Access Compliance Report

Public Rights-of-Way

Intersection ID: 27388	Main Street: CONLAN_CR	Cross Street: BRIXHAM_HILL_AV	Location: NW
ADA ID: 053A720393AA	Ramp Type: Para	Initial Pass/Fail: Fail	Overall Compliance: No
			Severity Score: 13.75

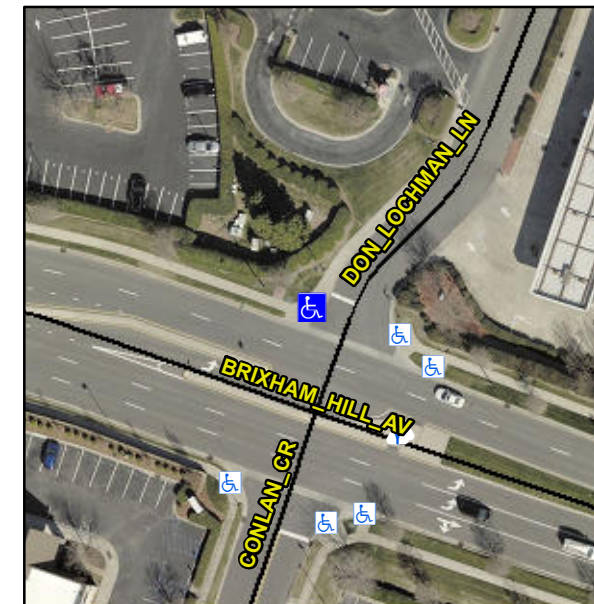
RT RP < 5%

R304.3.2, R304.5.3

Compliance	Description	Data	Compliance	Description	Data
N/A	Ramp Length LT (in)	30.0	N/A	Ramp Length RT (in)	40.0
Yes	Ramp Width LT (in)	60.0	Yes	Ramp Width RT (in)	60.0
No	Ramp Slope LT (%)	8.6	Yes	Ramp Slope RT (%)	1.3
No	Ramp XSlope LT (%)	2.3	No	Ramp XSlope RT (%)	2.5
N/A	Landing Length (in)	N/A	N/A	DWS Provided?	N/A
N/A	Landing Width (in)	N/A	N/A	DWS Contrast?	N/A
N/A	Landing Slope (%)	N/A	N/A	DWS Length (in)	N/A
N/A	Landing X Slope (%)	N/A	N/A	DWS Full Width?	N/A
N/A	Landing Curb? (Y/N)	N/A	N/A	DWS Offset (in)	N/A
N/A	Shared Landing?	N/A			
N/A	Gutter Ponding?	N/A	N/A	Gutter Slope (%)	N/A
N/A	Gutter Lip Ht (in)	N/A	N/A	Gutter X Slope (%)	N/A
N/A	Painted X Walk1?	No	N/A	Painted X Walk2?	N/A
	X Walk 1 Direction	To SE		X Walk 2 Direction	N/A
N/A	X Walk 1 Width (in)	N/A	N/A	X Walk 2 Width (in)	N/A
	X Walk 1 Slope (%)	2.3		X Walk 2 Slope (%)	N/A
	X Walk 1 X Slope (%)	6.4		X Walk 2 X Slope (%)	N/A
N/A	Ramp inside XWalk1?	N/A	N/A	Ramp inside XWalk2?	N/A

Remove & Replace Entire Ramp.
